Access Compliance Report

Public Rights-of-Way

Intersection ID: 16310	Main Street: LYNNVILLE_AV	Cross Street: N_SHARON_AMITY_RD	Location: N
ADA ID: 1364B8D90826	Ramp Type: PerpDiag	Initial Pass/Fail: Fail	Overall Compliance: No
Severity Score: 21.25			
Codes/Mitigation Info/Possible Solution		Field Measurements/Component Compliance

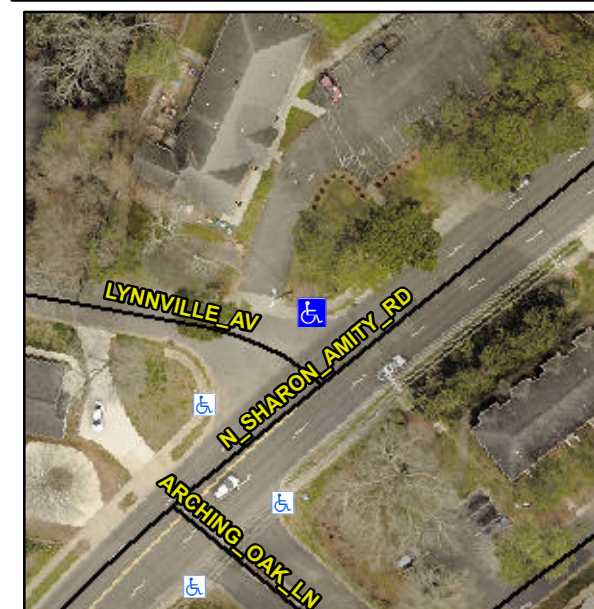
Not Found, R304.5.1, R304.5.3

Compliance	Description	Data	Compliance	Description	Data
N/A	Ramp Length (in)	84.0	Yes	Ramp Slope (%)	5.3
No	Ramp Width (in)	41.0	No	Ramp XSlope (%)	5.2
N/A	Flare Type LT	N/A	N/A	Flare Type RT	N/A
N/A	Flare Slope LT (%)	N/A	N/A	Flare Slope RT (%)	N/A
N/A	Flare Traversable LT?	N/A	N/A	Flare Traversable RT?	N/A
N/A	Landing Length (in)	N/A	N/A	DWS Provided?	N/A
N/A	Landing Width (in)	N/A	N/A	DWS Contrast?	N/A
N/A	Landing Slope (%)	N/A	N/A	DWS Length (in)	N/A
N/A	Landing X Slope (%)	N/A	N/A	DWS Full Width?	N/A
N/A	Landing Curb? (Y/N)	N/A	N/A	DWS Offset (in)	N/A
N/A	Shared Landing?	N/A			
N/A	Gutter Ponding?	Yes	N/A	Gutter Slope (%)	N/A
N/A	Gutter Lip Ht (in)	N/A	N/A	Gutter X Slope (%)	N/A
N/A	Painted X Walk1?	No	N/A	Painted X Walk2?	No
	X Walk 1 Direction	To SW		X Walk 2 Direction	To S
N/A	X Walk 1 Width (in)	N/A	N/A	X Walk 2 Width (in)	N/A
	X Walk 1 Slope (%)	2.2		X Walk 2 Slope (%)	1.2
	X Walk 1 X Slope (%)	1.3		X Walk 2 X Slope (%)	1.7

Remove & Replace Curb Ramp With Two New Directional Ramps or Equivalent.
